ENGINE - HP COMPRESSOR - CONTROLLED SERVICE USE OF INSTRUMENTATION FOR HP COMPRESSOR,
HANDLING BLEED VALVES AND CABIN AIR PRESSURE MONITORING CHECKS - NOT APPLICABLE -
MOD.ENG-72-0210

(1) Aircraft: Airbus A320

(2) Engine: V2500-A1 Engines, IAE to advise engine serial number and aircraft. This Service Bulletin must be incorporated only on one engine per aircraft. Do this Service Bulletin before you do Service Bulletin V2500-ENG-72-0209.

Repeat View at AN (see Fig.5) Showing 7th Stage Duct Before and After Alteration
Fig.14

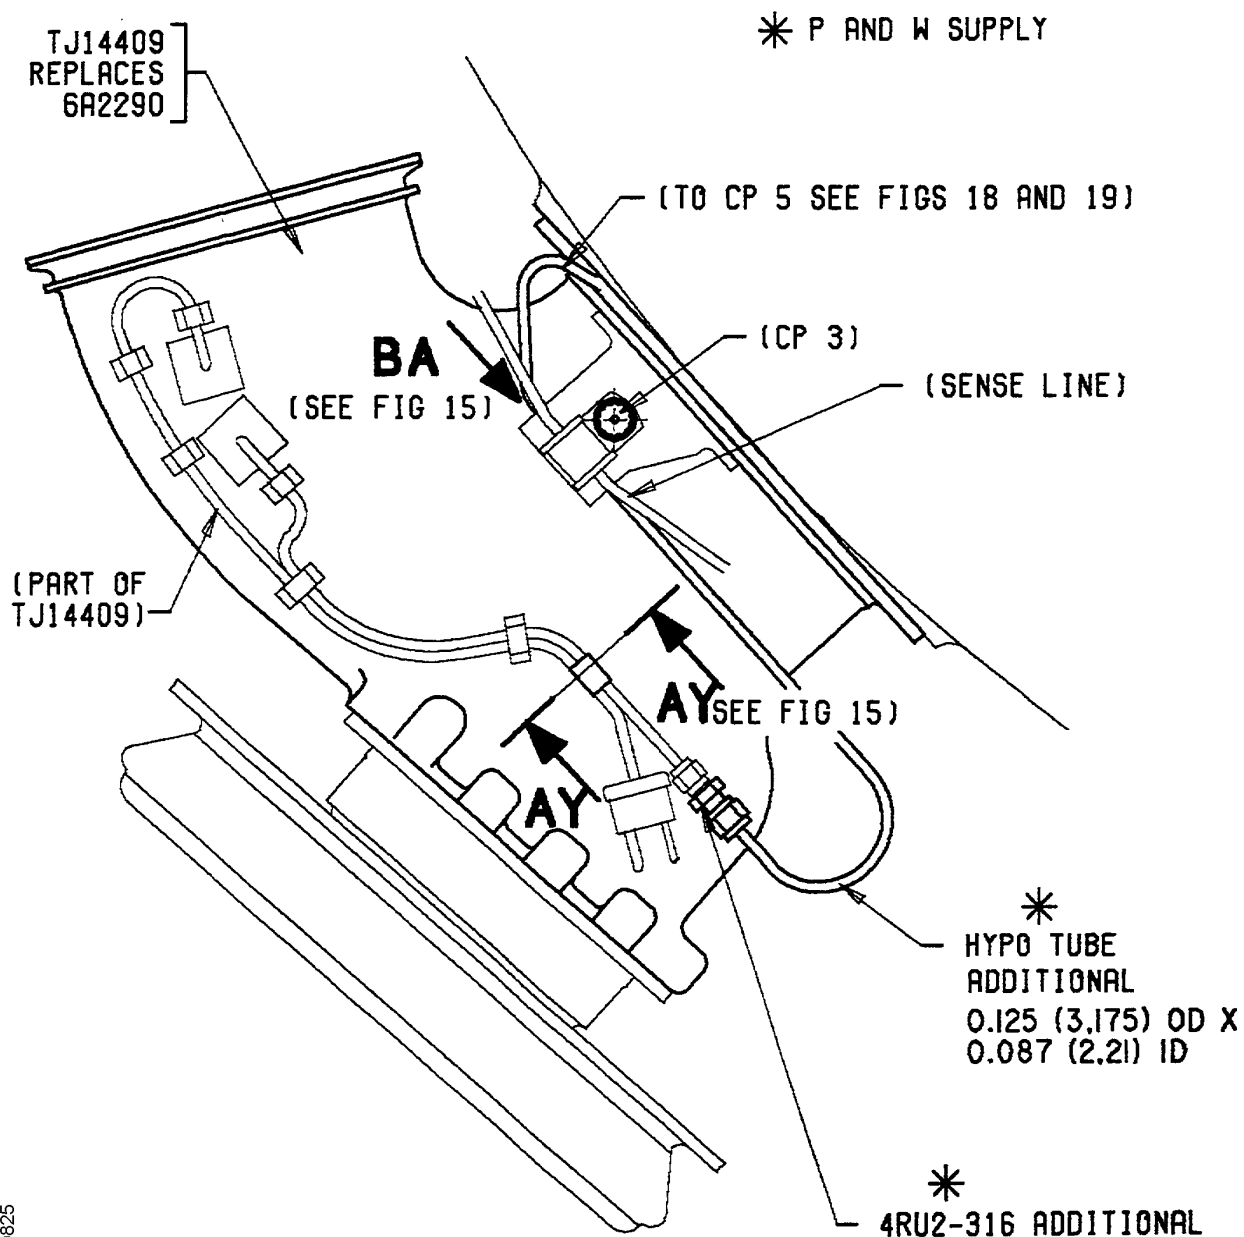
- (b) Remove the 12 bolts and the two brackets that attach the stage 7 air off-take duct to the HP compressor case.
- (9) Install the instrumented stage 7 lower left hand air off-take duct. Refer to Figures 5, 13 and 14.

- (a) Position the air off-take duct on the HP compressor case with the angled duct to the top and align the bolt holes.
 - (b) Install the 12 bolts together with the two brackets. Torque the bolts to 85 to 105 lbfin (10 to 12 Nm).

View on Arrow BA (see Fig.14) Showing Clipping Point 3 Before and After Alteration
Fig.15

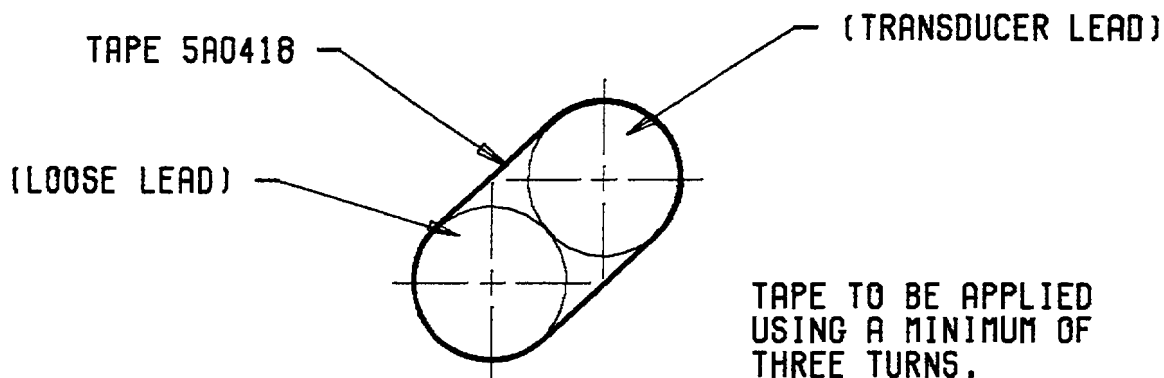
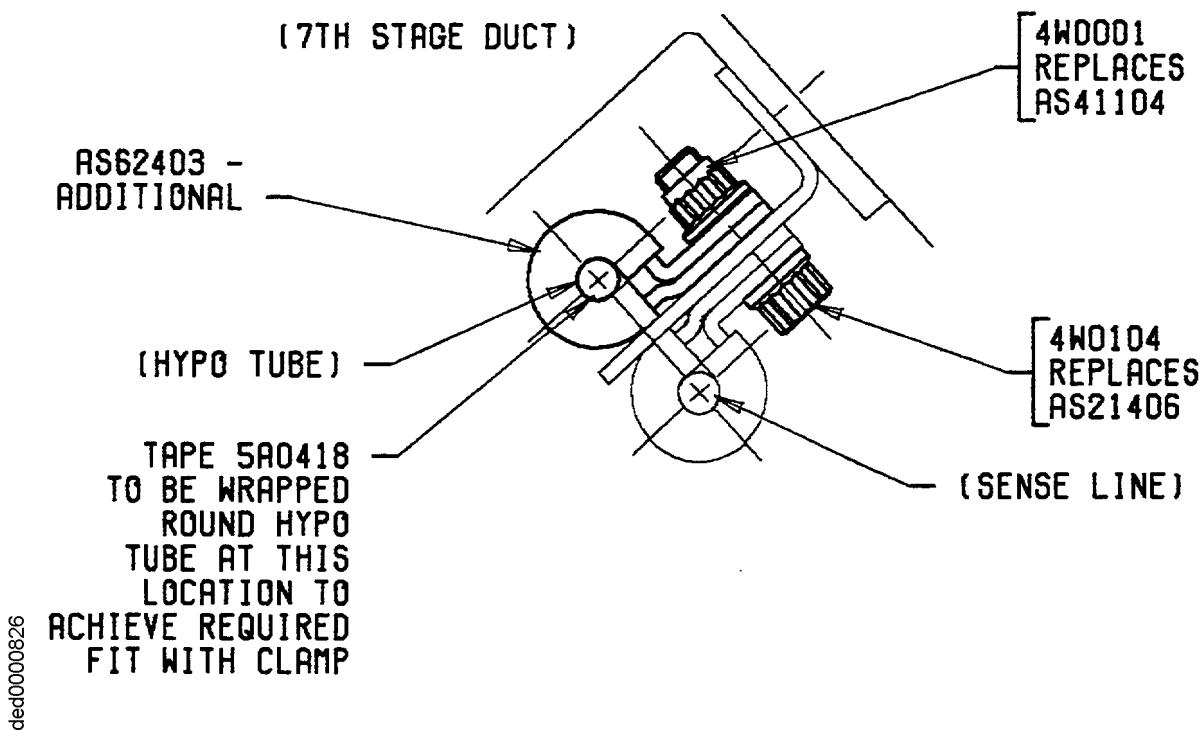
- (38) At new clipping point 3, wrap hypo tube sufficiently with 5A0418 tape to achieve required fit with AS62403 clamp. Assemble clipping point using 4W0104 bolt and 4W0001 nut. Refer to Figures 14 and 15.

(39) Secure loose lead to hypo tube using 5A0418 tape. Refer to Figures 14 and 15.

View on Arrow BC (see Fig.5) Shown thus for Convenience Showing H.P. Valve Before
Alteration
Fig.16

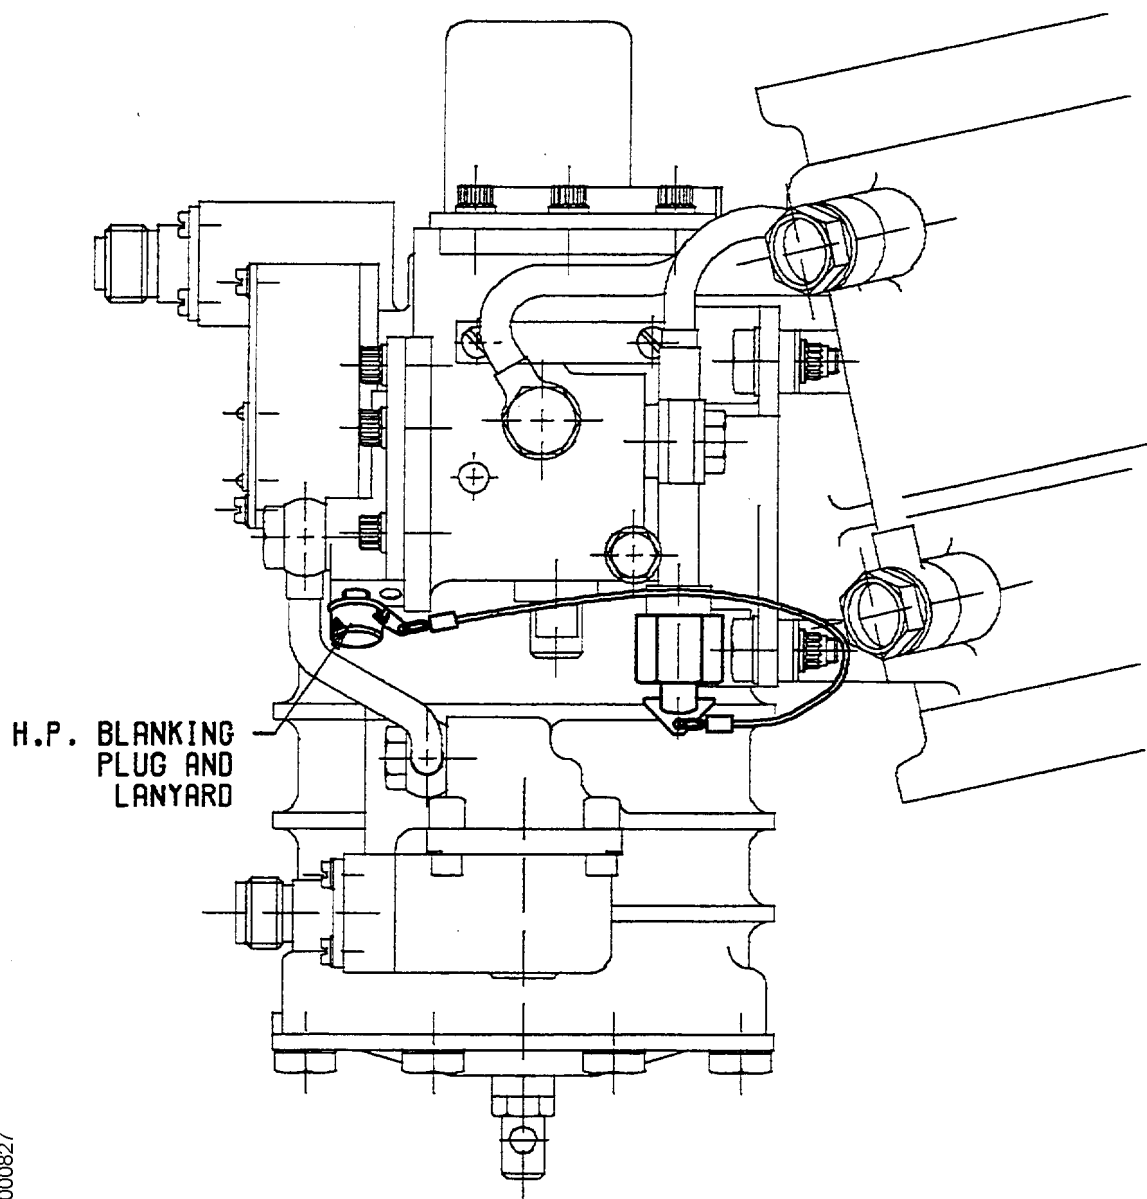
- (33) At the HP valve, disconnect the HP blanking plug and remove the lanyard from the HP valve, hold part. Refer to Figures 1, 2, 5, 16 and 17.
- (34) Install a length of hypo tube to the instrumented stage 7 lower left hand air off-take duct and transducer running the tubing through the bifurcation panel holes. When assembling the gyrolok fittings to hypo tubes insert the tubing, resting it in the bottom of the body counterbore. Make sure the nut is finger tight, tighten the nut a further 1 1/4 turns. Refer to Figures 1, 2, 5, 14, 18, 21, 23, 24, 25 and 27.

NOTE:
H.P. BLANKING PLUG AND LANYARD TO BE REMOVED
AND STORED IN A SAFE AND CONVENIENT PLACE

Repeat View on Arrow BC (see Fig.5) Shown thus for Convenience Showing H.P. Valve
After Alteration
Fig.17

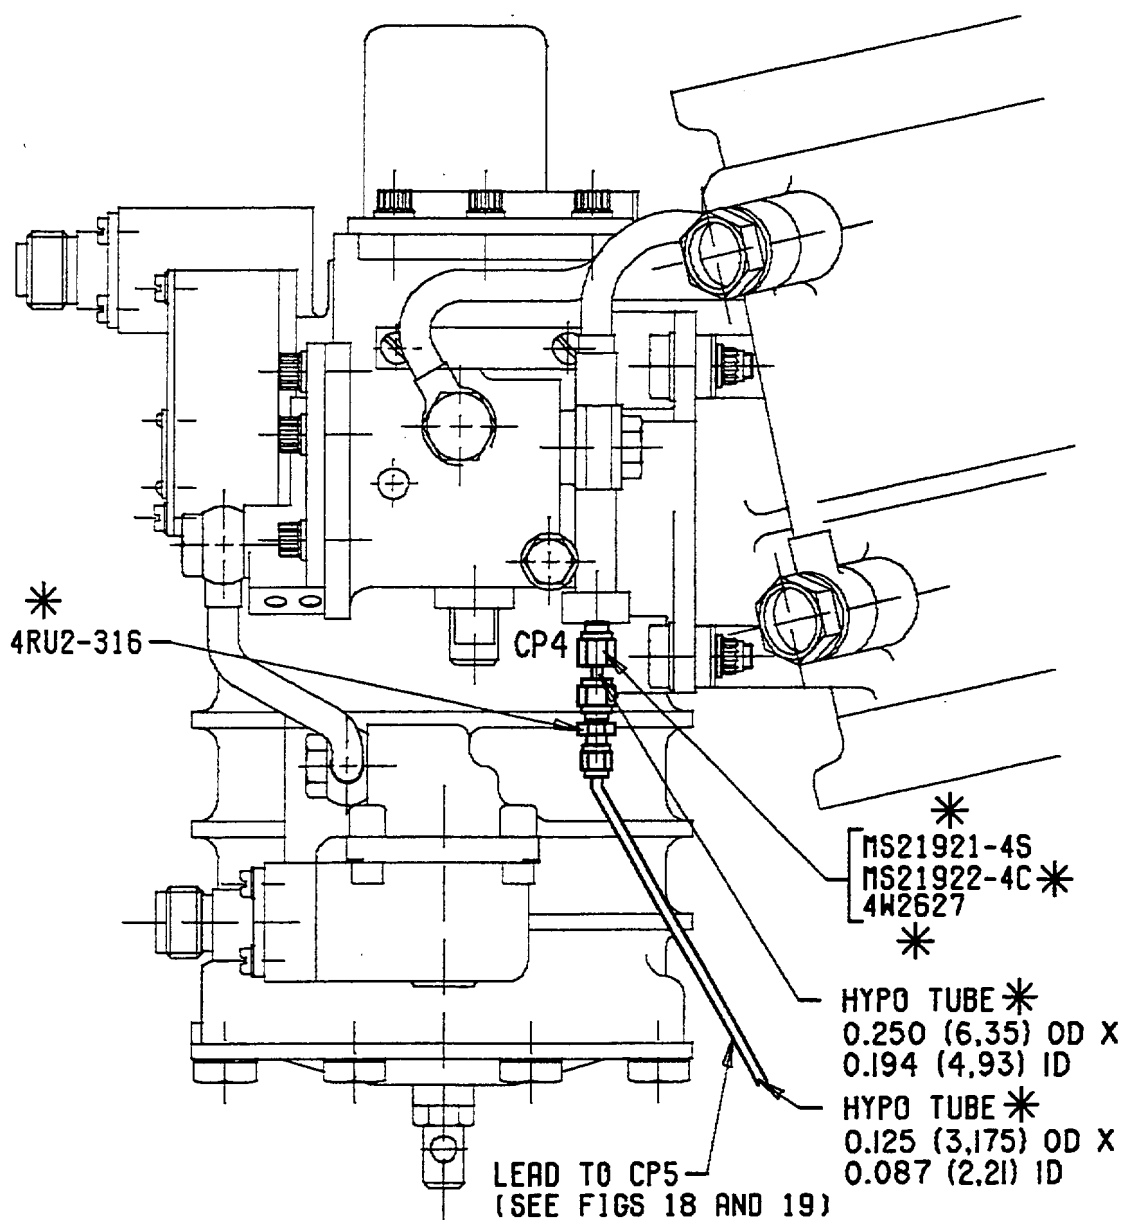
- (35) Install a length of hypo tube to the HP valve and transducer running the tubing through the bifurcation panel holes. When assembling the gyrolok fittings to hypo tubes insert the tubing resting it in the bottom of the body counterbore. Make sure the nut is finger tight, tighten the nut a further 1 1/4 turns. Refer to Figures 1, 2, 5, 17, 18, 21, 23, 24, 25 and 27.

- (36) Safety the hypo end connection at the HP valve using lockwire. Refer to Figure 17.
- (37) Install the electrical cable end connectors (2 off) to the transducers (2 off). Refer to Figure 27.

Section BG (see Fig.21) After Alteration
Fig.22

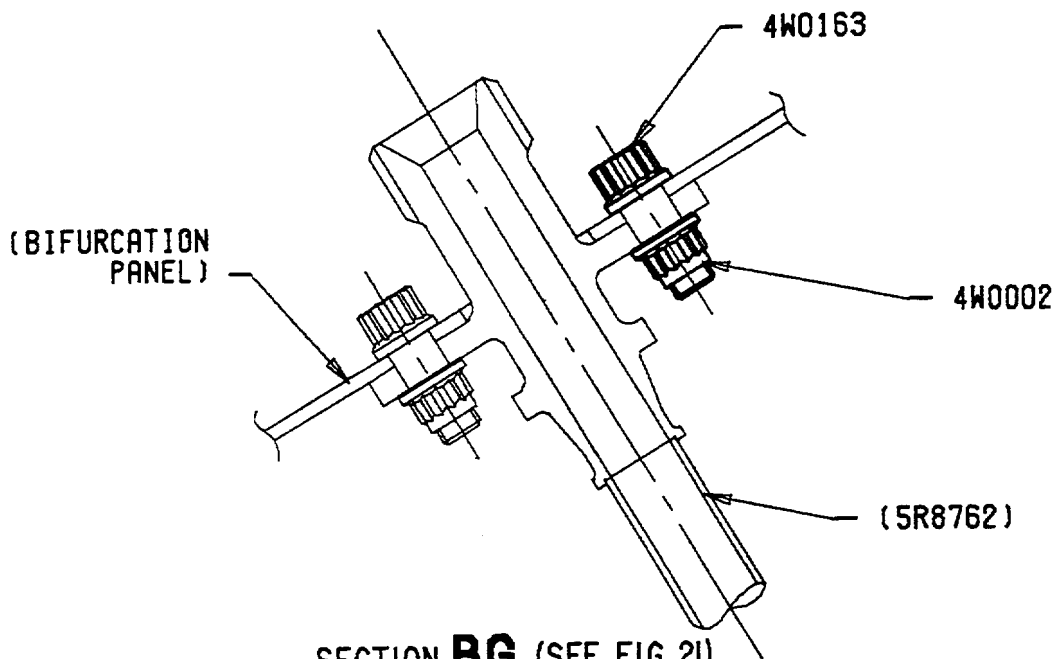
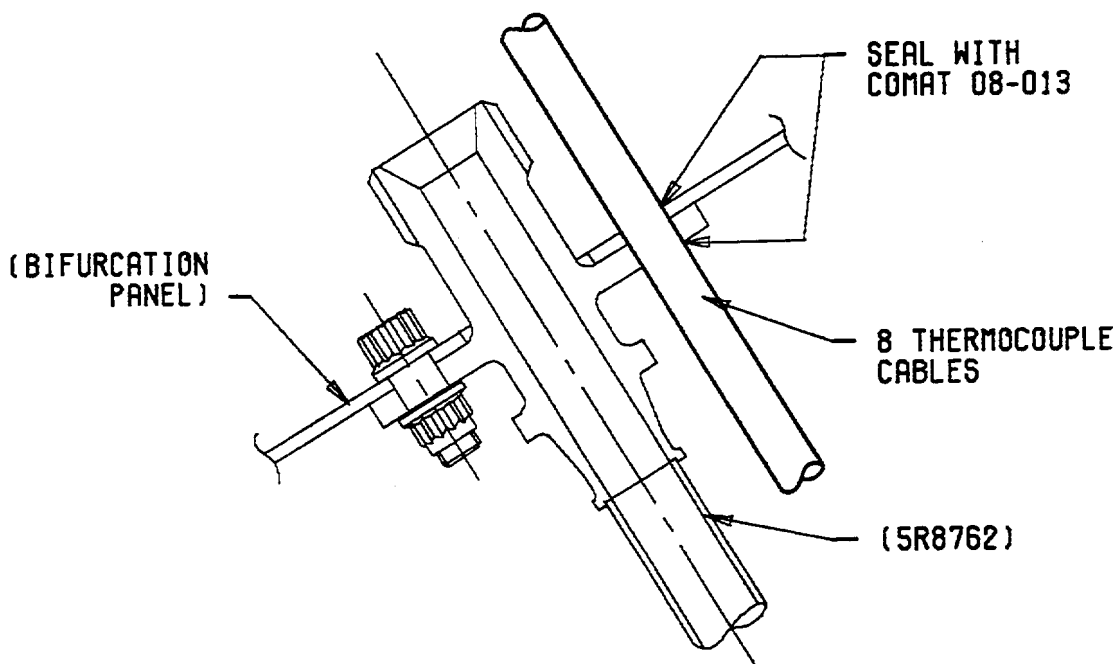
- (32) At the bifurcation panel, disassemble 4W0163 (3 off) and 4W0002 nuts (3 off) at locations BG, BH and BJ, remove and hold parts. Refer to Figures 1, 18, 21, 23 and 24.

(43) At the bifurcation panel split the bundle into three groupings and feed through the panel holes (3 off). Refer to Figures 18,21,22,23, and 24.

View Looking Forward Clipping Point 9 (see Fig.21) Added
Fig.26

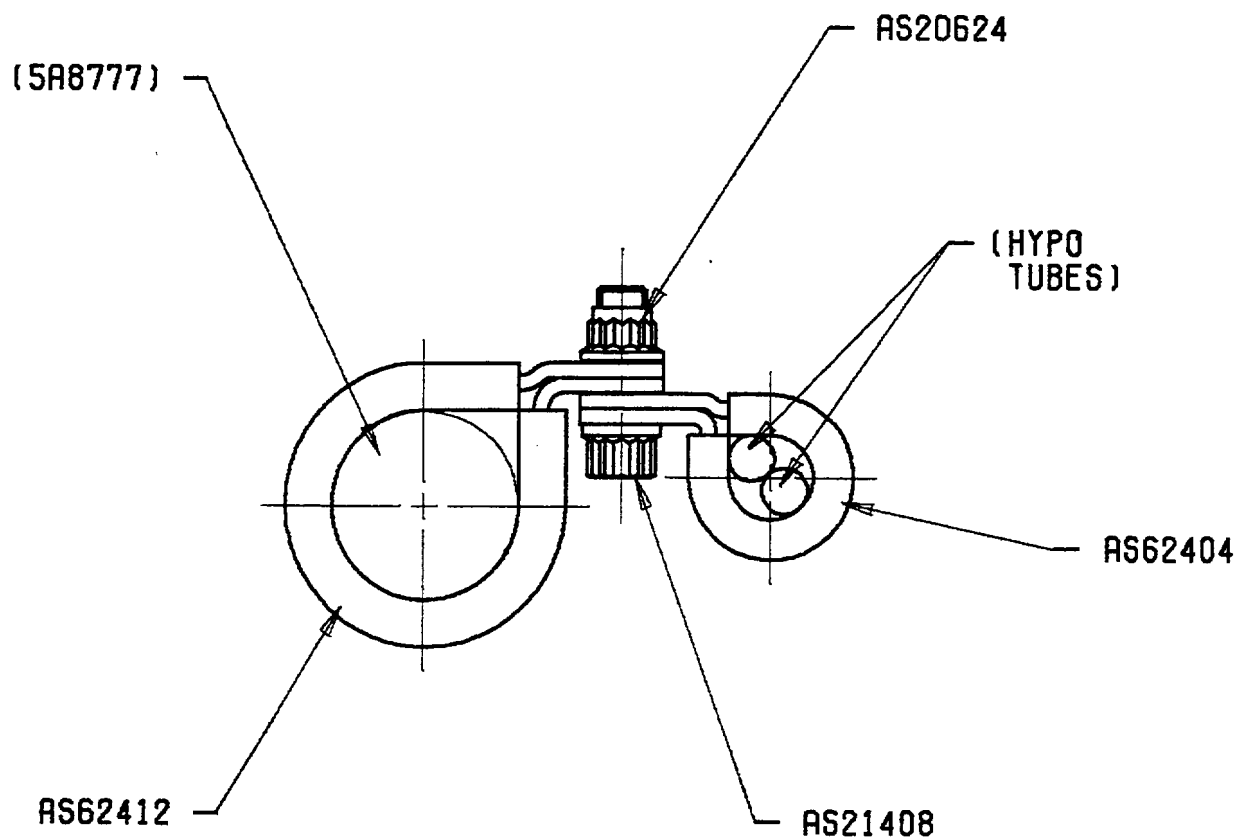
(45) At new clipping point 9, install AS62412 clamp to 5A8777 tube, install hypo tubes (2 off) to AS62404 clamp and secure using AS21408 bolt and AS20624 nut. Refer to Figures 25 and 26.

Enlarged View at BL (see Fig.25) Showing Transducers Added
Fig.27

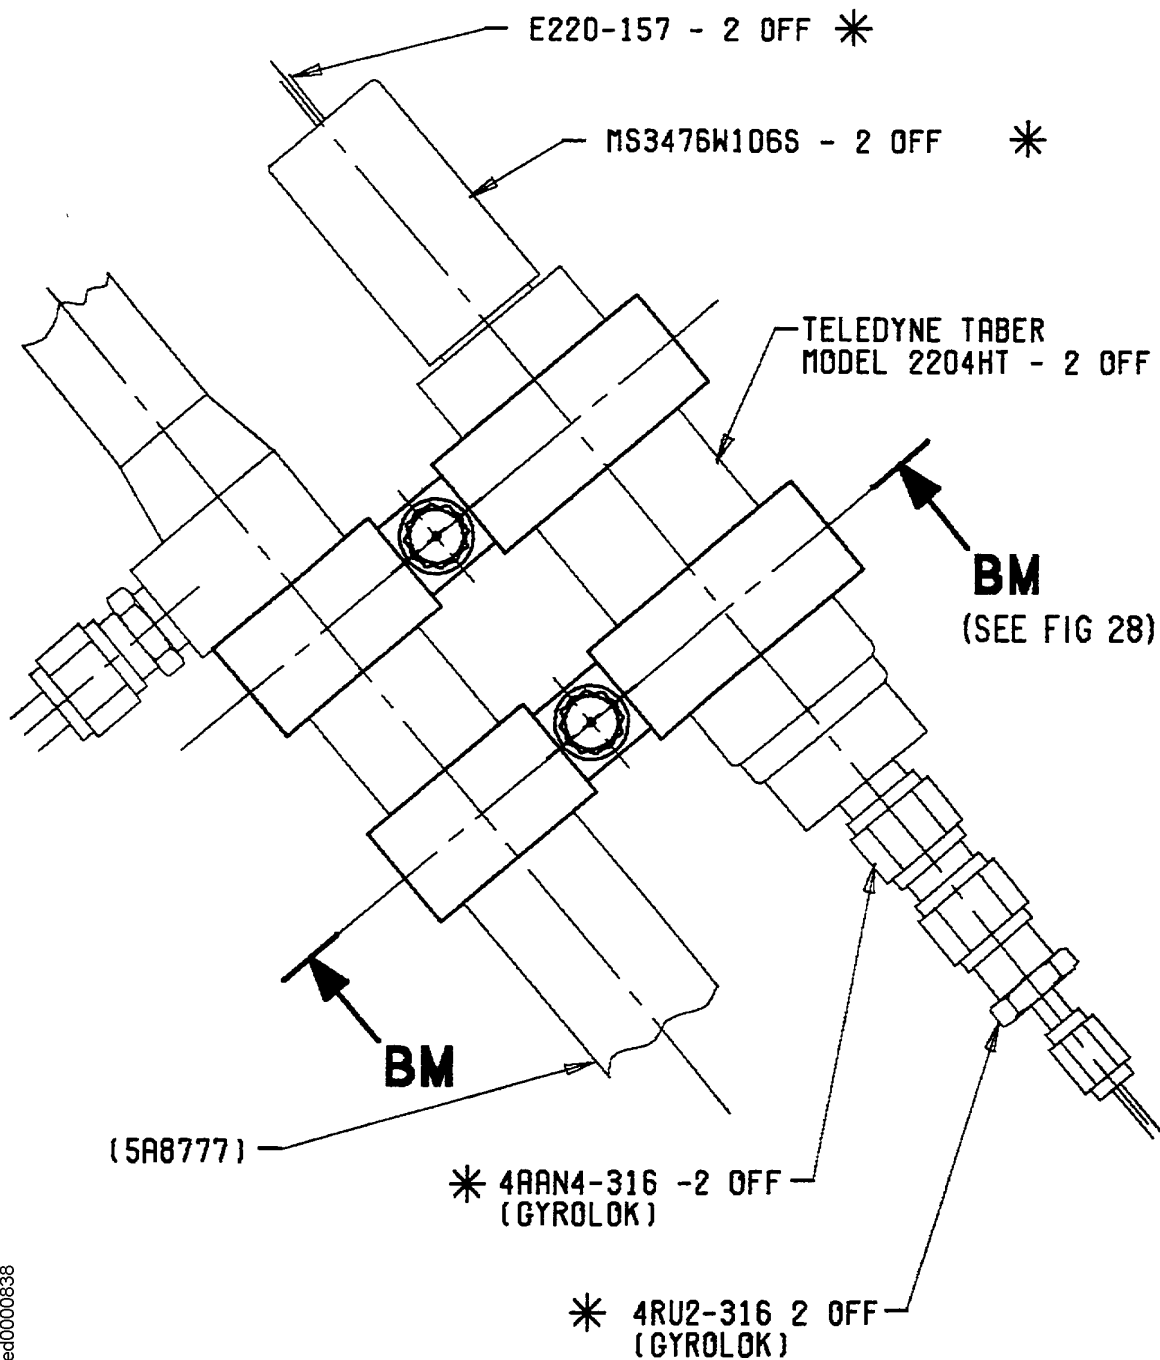
- (31) Find 5A8777 tube, Install the transducers (2off) to the 5A8777 tube adjacent to fan case bottom dead centerline using AS62416 clamps (4 off) AS62412 clamps (2 off) AS21409 bolts (2 off) and AS20624 nuts (2 off). Refer to Figures 1, 25, 27 and 28.
